<b>Title - Sujet</b> HVAC Upgrade Services	
<b>Solicitation No. - N° de l'invitation</b> EP922-210258/A	<b>Amendment No. - N° modif.</b> 004
<b>Client Reference No. - N° de référence du client</b> CFIA EP922-210258	<b>Date</b> 2020-08-30
<b>GETS Reference No. - N° de référence de SEAG</b> PW-SPWU-183-11872	
<b>File No. - N° de dossier</b> PWU-0-43037 (183)	<b>CCC No./N° CCC - FMS No./N° VME</b>
<b>Solicitation Closes - L'invitation prend fin</b> <b>at - à 02:00 PM</b> <b>on - le 2020-09-08</b>	<b>Time Zone</b> <b>Fuseau horaire</b> Mountain Daylight Saving Time MDT
<b>F.O.B. - F.A.B.</b> <b>Plant-Usine:</b> <input type="checkbox"/> <b>Destination:</b> <input type="checkbox"/> <b>Other-Autre:</b> <input type="checkbox"/>	
<b>Address Enquiries to: - Adresser toutes questions à:</b> Tikhonovitch (RPC), Alex	<b>Buyer Id - Id de l'acheteur</b> pwu183
<b>Telephone No. - N° de téléphone</b> (780) 901-7940 ( )	<b>FAX No. - N° de FAX</b> (780) 497-3510

File: 115303307 Lethbridge Lab AHU Replacement  
Addendum No: ADD-M02  
Date: August 27, 2020  
Owner: Canadian Food Inspection Agency, Public Services and Procurement Canada /  
Government of Canada

**Details of the Addendum:**

Project No.: M404  
Revision: 1  
Date: 2023-07-27

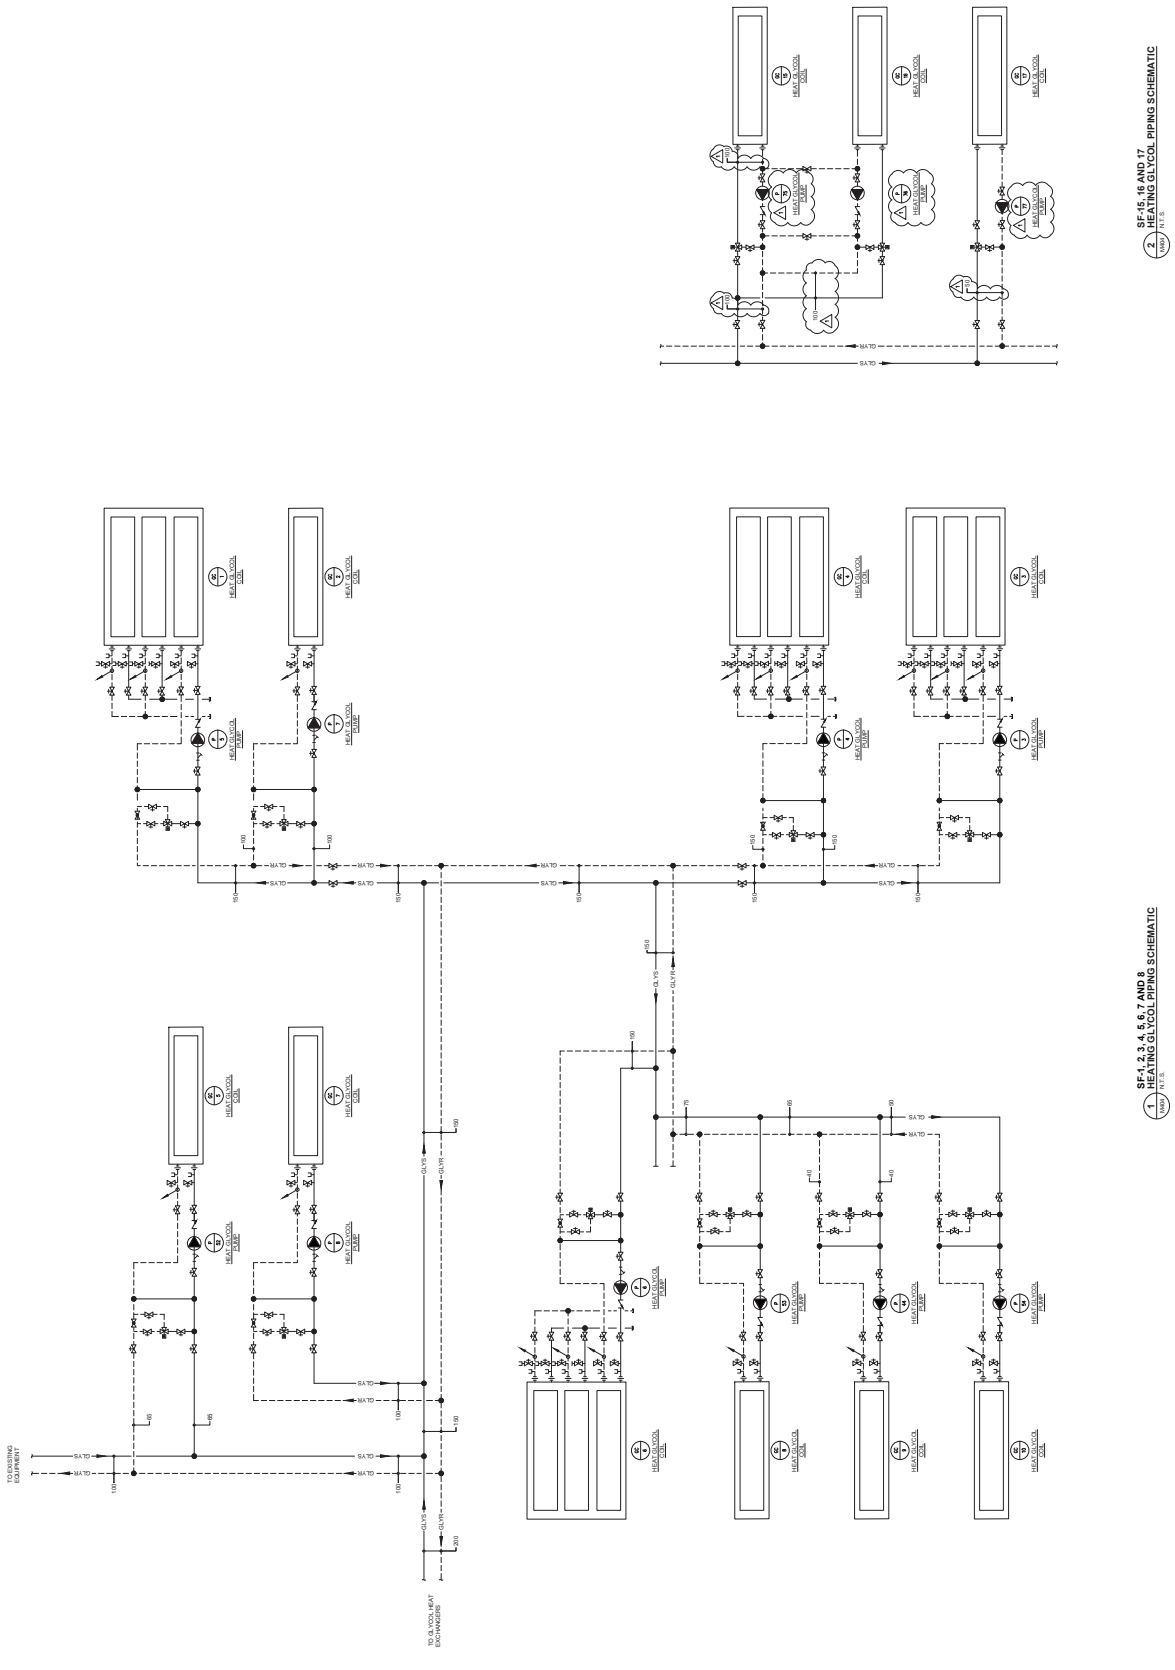
1. SPECIFICATIONS
  - .1 Section 23 25 19 – Steam System Cleaning and Chemical Treatment added
2. DRAWINGS
  - .1 M404 – MECHANICAL SCHEMATICS HEATING GLYCOL
    - i. Added pipe sizes for SF-15, SF-16, and SF-17. Glycol piping serving SF-15 and SF-16 to be 100Ø. SF-17 to be 50Ø.
    - ii. Revised pump tags serving SF-15, SF-16, and SF-17 to match schedules.
  - .2 M500 – MECHANICAL DETAILS
    - i. Added all-in-one chemical treatment system to steam humidification schematic including chemical pump, chemical feed tank, water meter, and control panel.
    - ii. Added breeching thru roof detail.
